ACME ELECTRIC
AS-BUILT

WESTCLIFF DRIVE IMPROVEMENTS
CIMARRON ROAD TO RAINBOW BLVD
SIGNAGE AND STRIPING
NDOT SIGN DETAIL

SHEET
TS-06
42 OF 47 SHEETS
DRAWING NO.
107-V3099

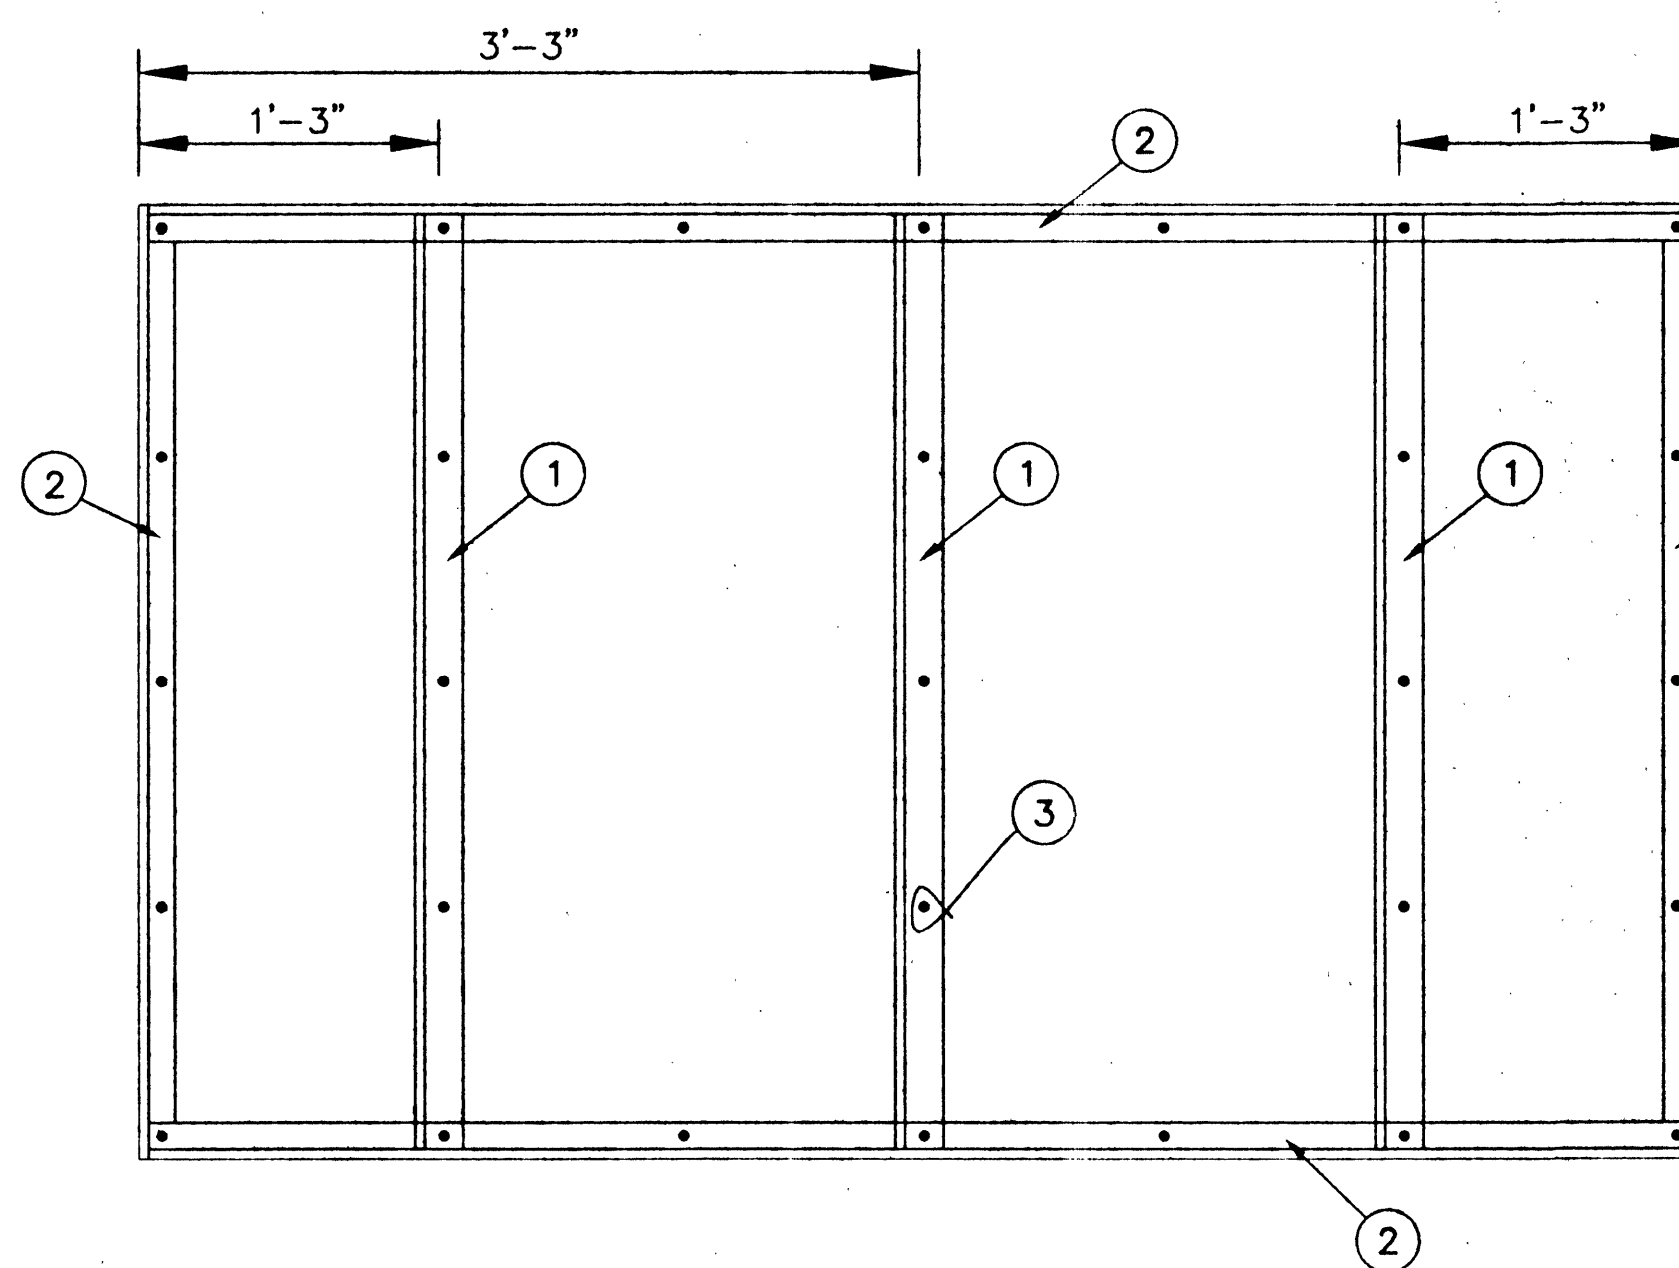
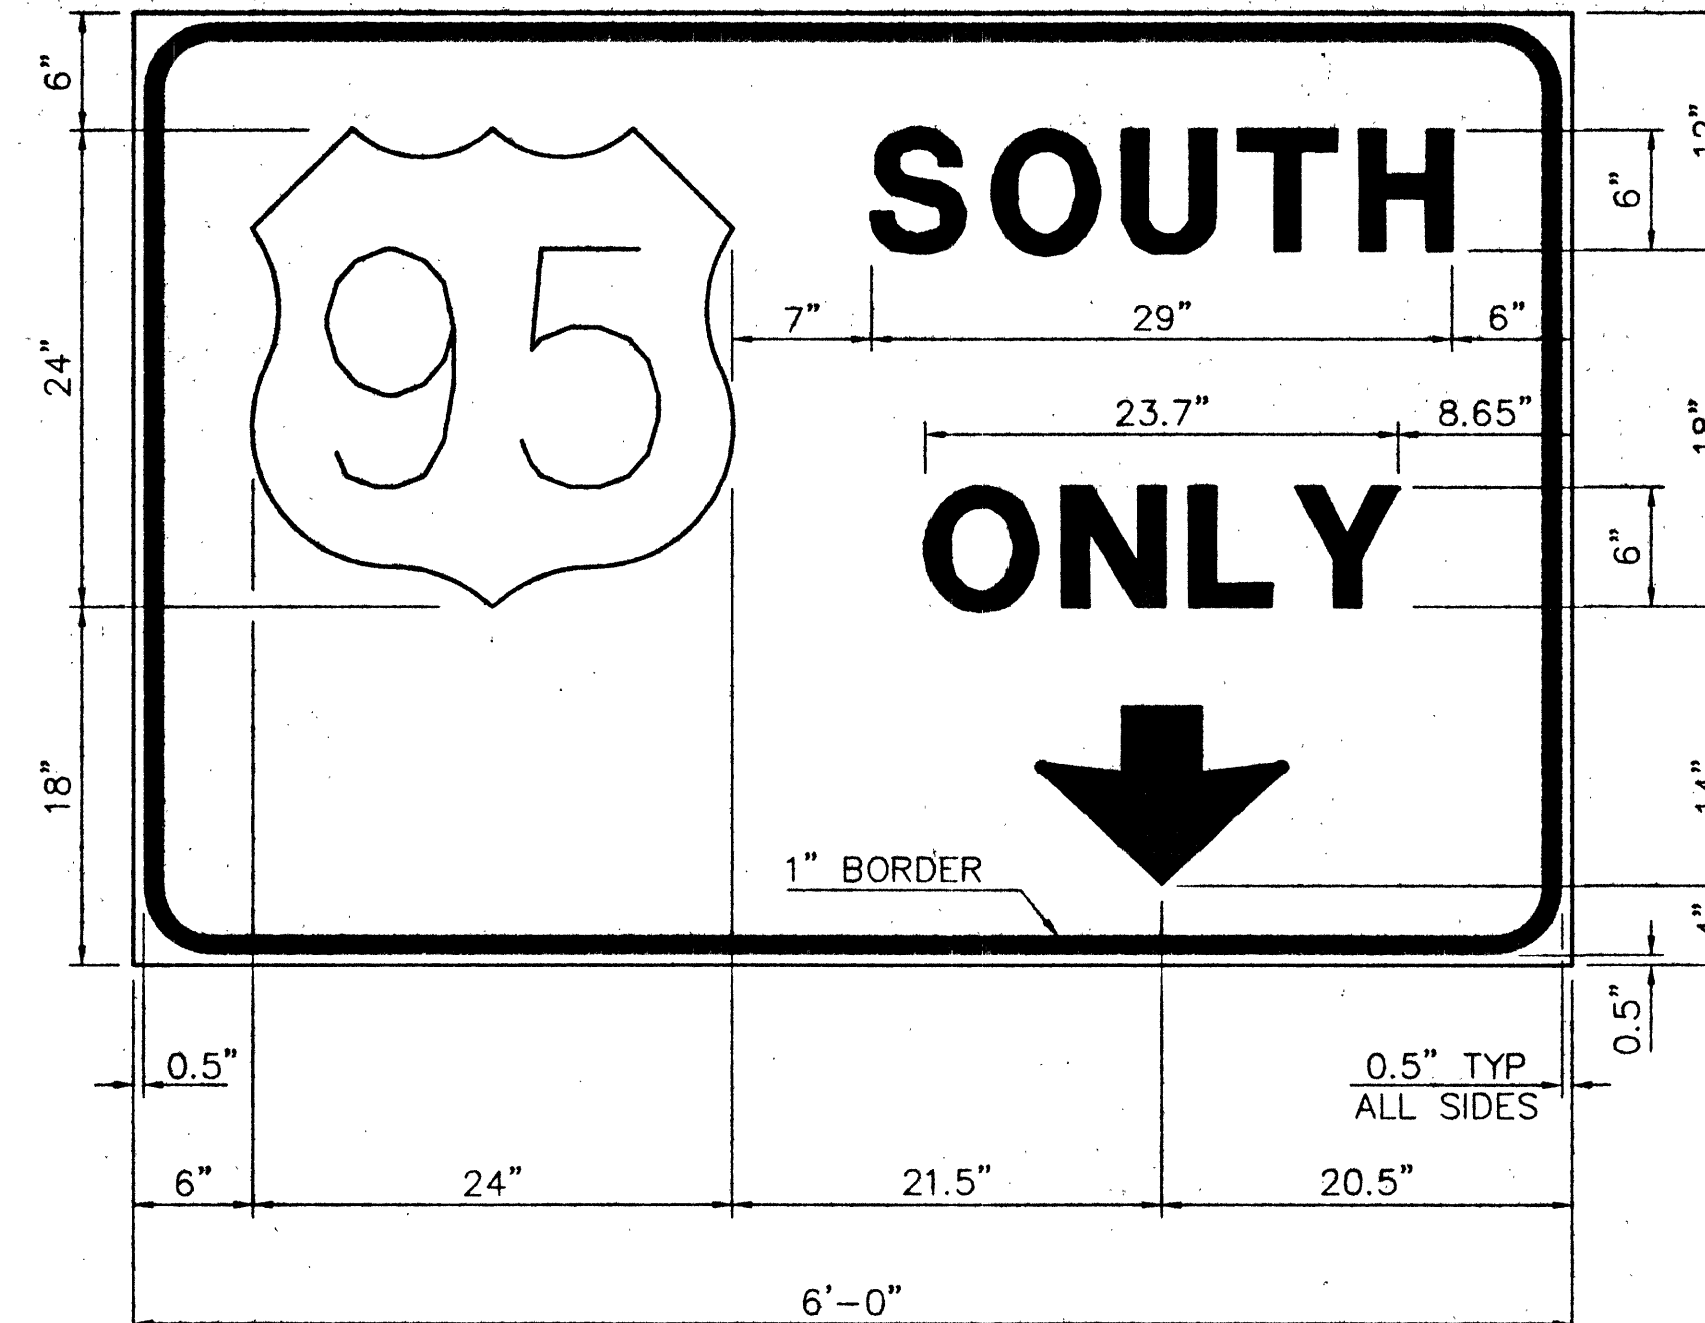
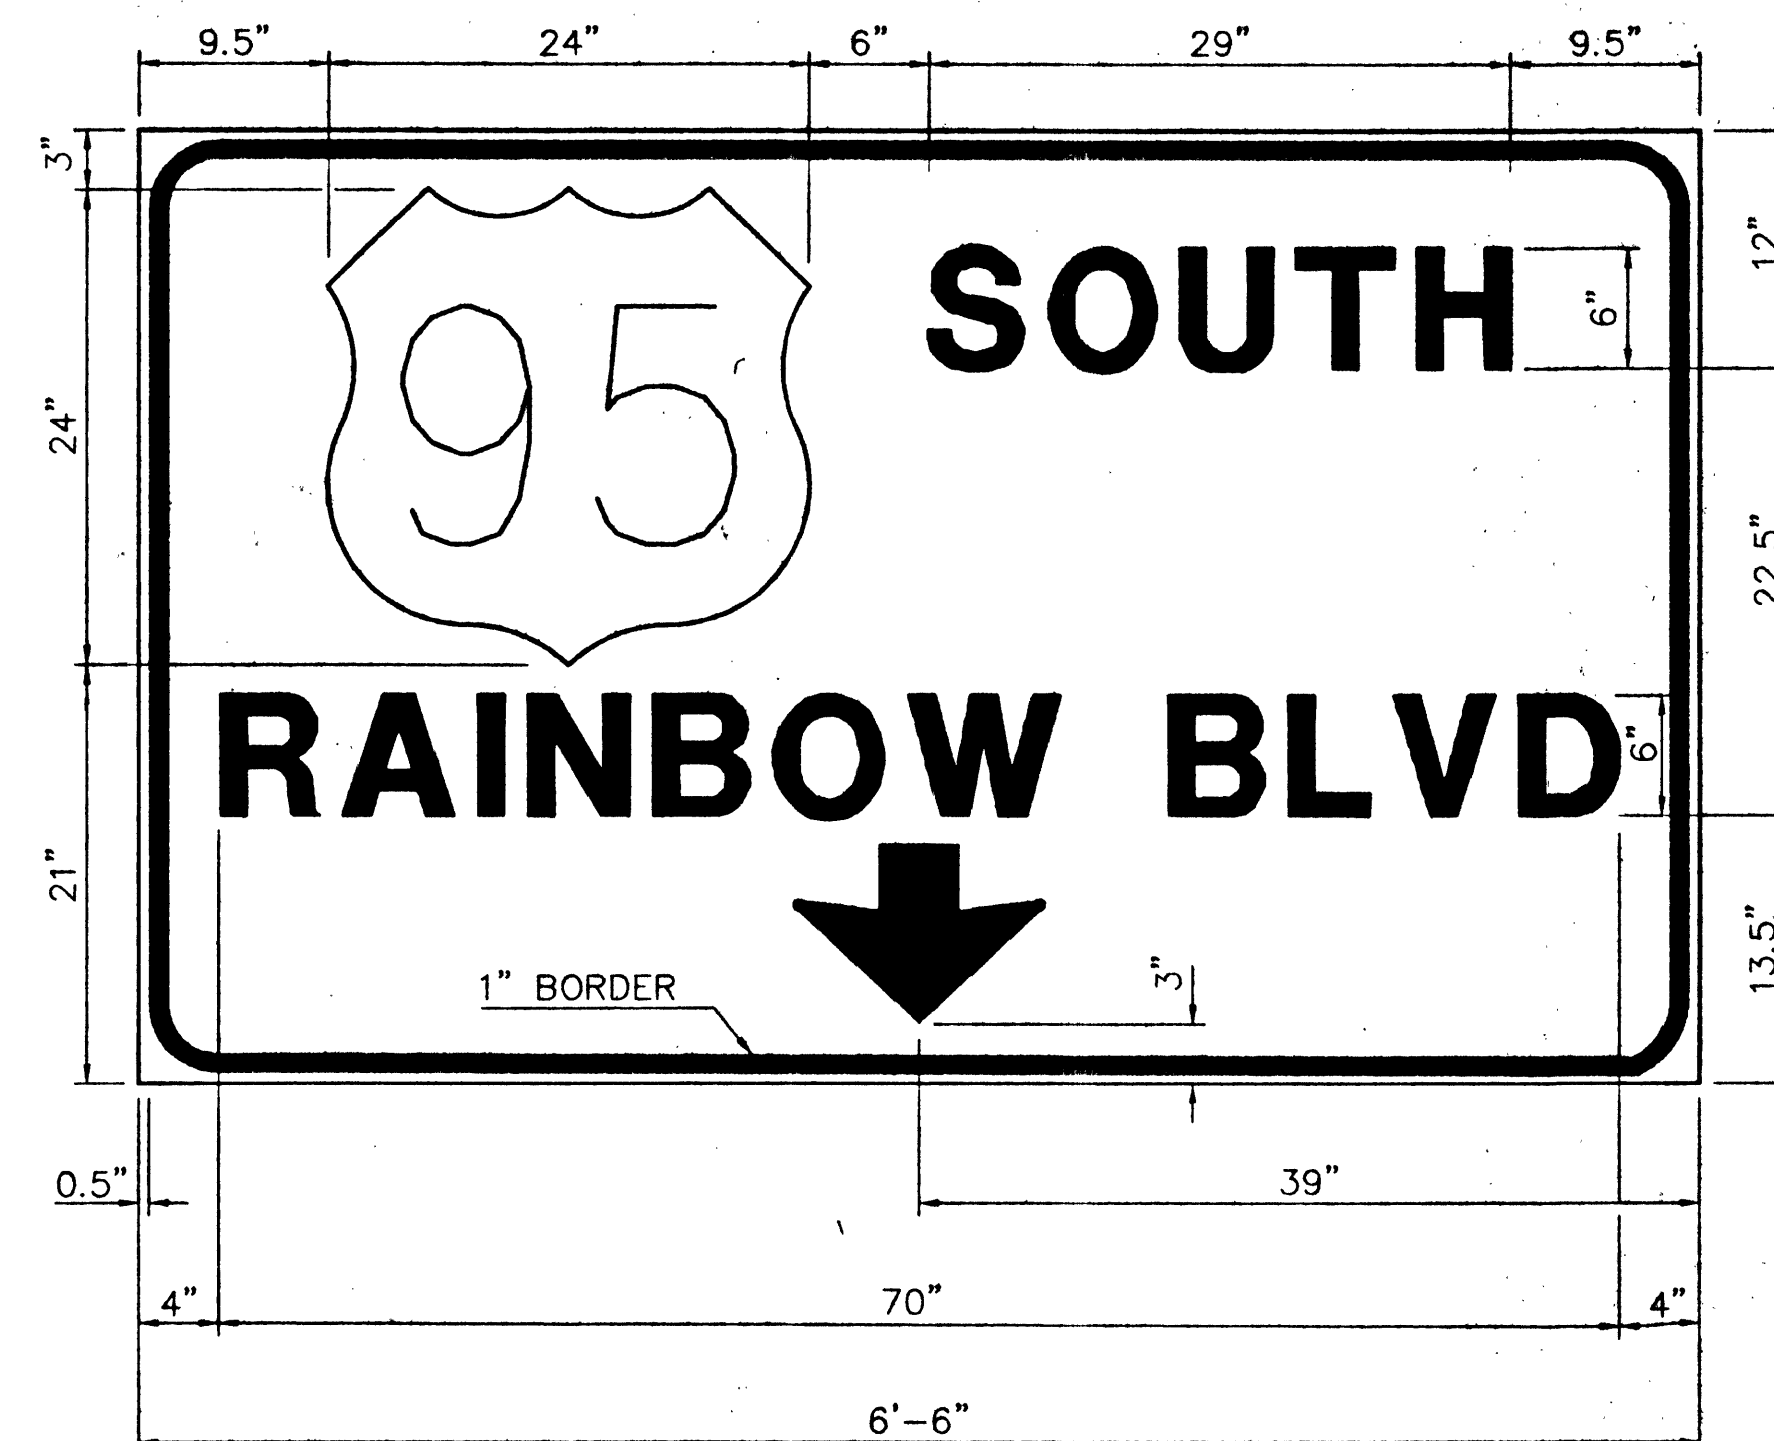
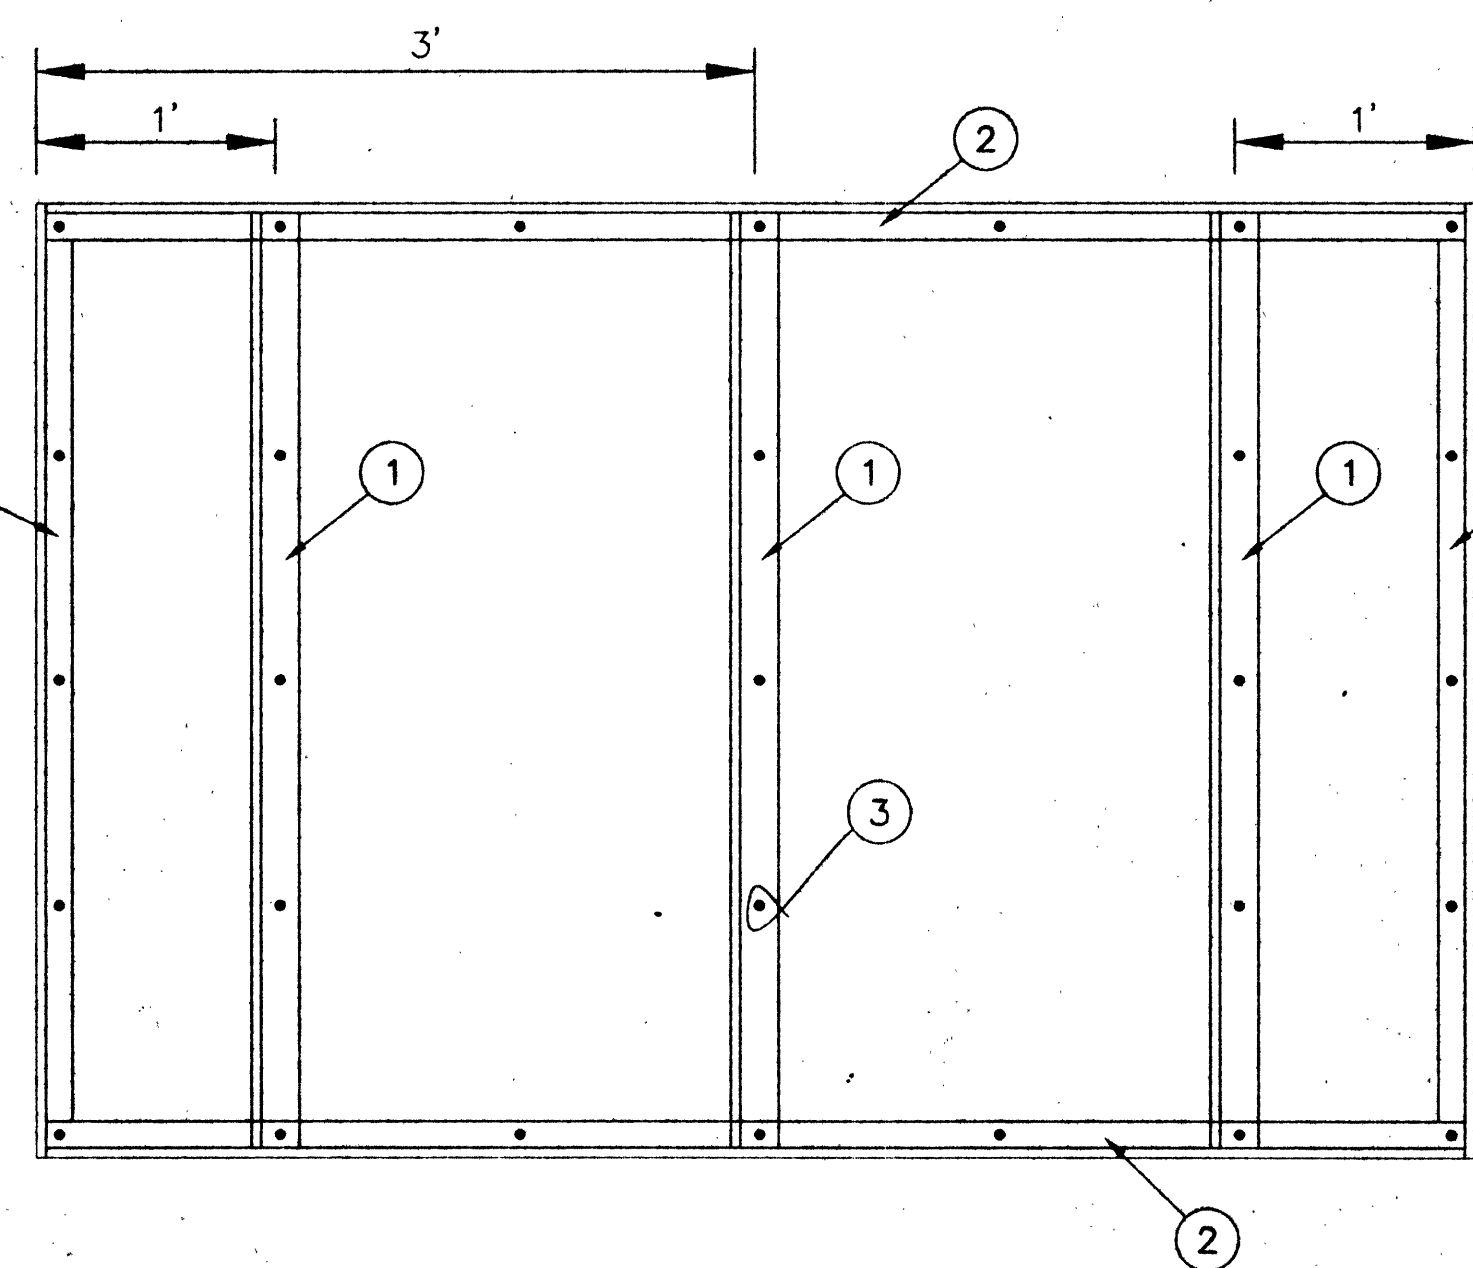
Signature
8/1/09
Date
ALL CHANGES TO THE APPROVED
DRAWINGS ARE NOTED IN RED.
